SUBJECT: NORTH ANNA UNITS 1 AND 2 - ISSUANCE OF AMENDMENTS RE:  
PRESSURE/TEMPERATURE OPERATING LIMITS AND LOW  
TEMPERATURE/OVERPRESSURE PROTECTION SYSTEM SETPOINTS  
(TAC NOS. M83154 AND M83155)

The amendments revise the pressure/temperature (P/T) operating limitations during heatup and cooldown and the low temperature/overpressure protection systems (LTOPS) setpoints for 12 and 17 effective full power years for NA-1&2, respectively.

AMENDMENT NO. 170 TO FACILITY OPERATING LICENSE NO. NPF-4-NORTH ANNA UNIT 1  
AMENDMENT NO. 149 TO FACILITY OPERATING LICENSE NO. NPF-7-NORTH ANNA UNIT 2

Amendment No. 170  
License No. NPF-4

Figure 3.4-2 Unit 1 RCS HEATUP P/T Limits  
 Valid to 12 EFY Heatup Rates: 0-60°F/Hr.  
 (Margins for Instrument Errors NOT Included)

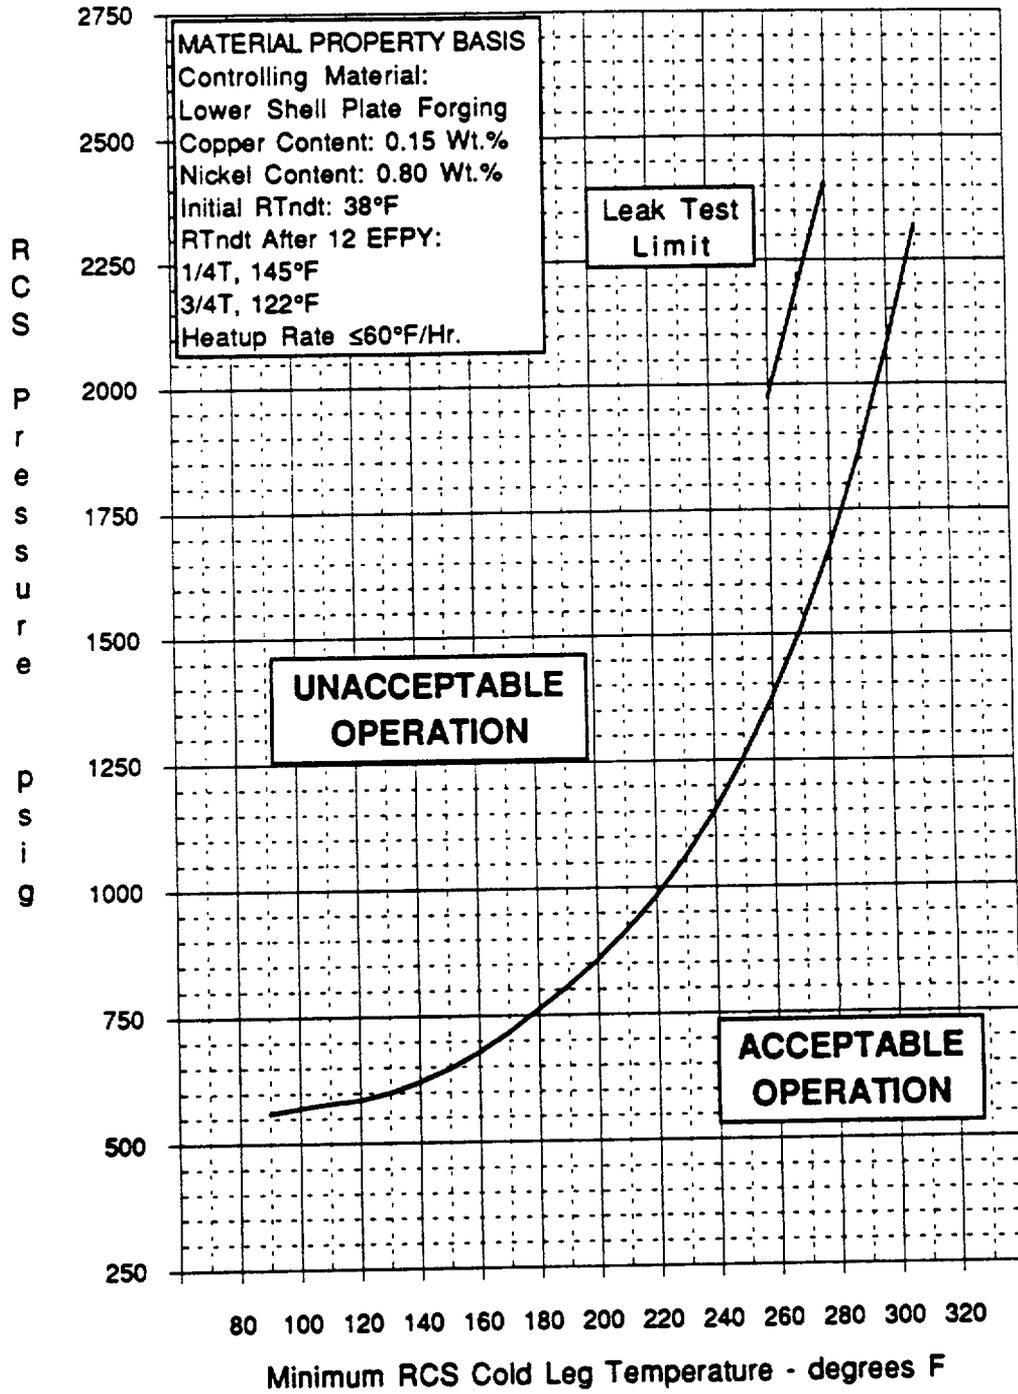
- 3.4.9.1 The Reactor Coolant System (except the pressurizer) temperature and pressure shall be limited in accordance with the limit lines shown in Figures 3.4-2 and 3.4-3 during heatup, cooldown, and inservice leak and hydrostatic testing with:
- a. A maximum heatup of 60°F in any one hour period.
  - b. A maximum cooldown of 100°F in any one hour period.
  - c. A maximum temperature change of less than or equal to 10°F in any one hour period during inservice hydrostatic and leak testing operations above the heatup and cooldown limit curves.

The heatup limit curve, Figure 3.4-2, is a composite curve which was prepared by determining the most conservative case, with either the inside or outside wall controlling for any heatup rate up to 60°F per hour. The cooldown limit curves of Figure 3.4-3 are composite curves which were prepared based upon the same type analysis with the exception that the controlling location is always the inside wall where the cooldown thermal gradients tend to produce tensile stresses while producing compressive stresses at the outside wall. The heatup and cooldown curves are prepared based upon the most limiting value of the predicted adjusted reference temperature at the end of 12 EFPY. The adjusted reference temperature was calculated using results from a capsule removed after the sixth fuel cycle. The results are documented in Westinghouse Report WCAP-11777, February 1988 and Babcock and Wilcox Report BAW-2146, October, 1991.

The pressure-temperature limit lines shown on Figure 3.4-2 for inservice leak and hydrostatic testing have been provided to assure compliance with the minimum temperature requirements of Appendix G to 10 CFR 50. The minimum temperature for criticality specified in T.S. 3.1.1.5 assures compliance with the criticality limits of 10 CFR 50 Appendix G.

Figure 3.4-2 Unit 2 RCS HEATUP P/T Limits  
 Valid to 17 EFPY Heatup Rates: 0-60°F/Hr.  
 (Margins for Instrument Errors NOT Included)

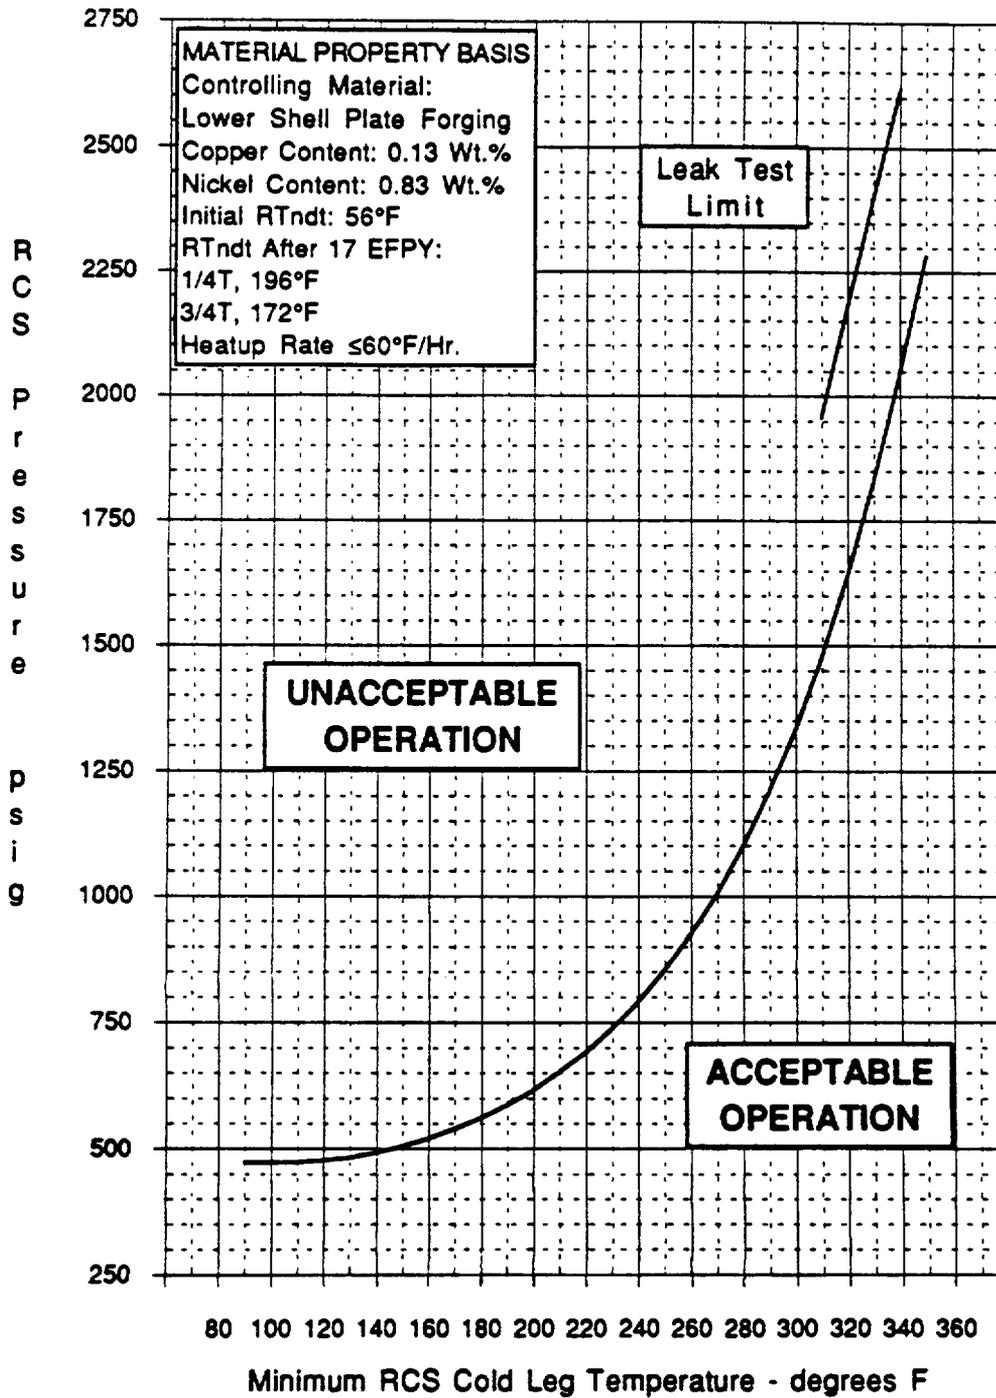
- 3.4.9.1 The Reactor Coolant System (except the pressurizer) temperature and pressure shall be limited in accordance with the limit lines shown in Figures 3.4-2 and 3.4-3 during heatup, cooldown, and inservice leak and hydrostatic testing with:
- a. A maximum heatup of 60°F in any one hour period.
  - b. A maximum cooldown of 100°F in any one hour period.
  - c. A maximum temperature change of less than or equal to 10°F in any one hour period during inservice hydrostatic and leak testing operations above the heatup and cooldown limit curves.

The heatup limit curve, Figure 3.4-2, is a composite curve which was prepared by determining the most conservative case, with either the inside or outside wall controlling for any heatup rate up to 60°F per hour. The cooldown limit curves of Figure 3.4-3 are composite curves which were prepared based upon the same type analysis with the exception that the controlling location is always the inside wall where the cooldown thermal gradients tend to produce tensile stresses while producing compressive stresses at the outside wall. The heatup and cooldown curves are prepared based upon the most limiting value of the predicted adjusted reference temperature at the end of 17 EFPY. The adjusted reference temperature was calculated using results from a capsule removed after the sixth fuel cycle. The results are documented in Westinghouse Report WCAP-12497, January 1990 and WCAP-12503, March, 1990.

The pressure-temperature limit lines shown on Figure 3.4-2 for inservice leak and hydrostatic testing have been provided to assure compliance with the minimum temperature requirements of Appendix G to 10 CFR 50. The minimum temperature for criticality specified in T.S. 3.1.1.5 assures compliance with the criticality limits of 10 CFR 50 Appendix G.
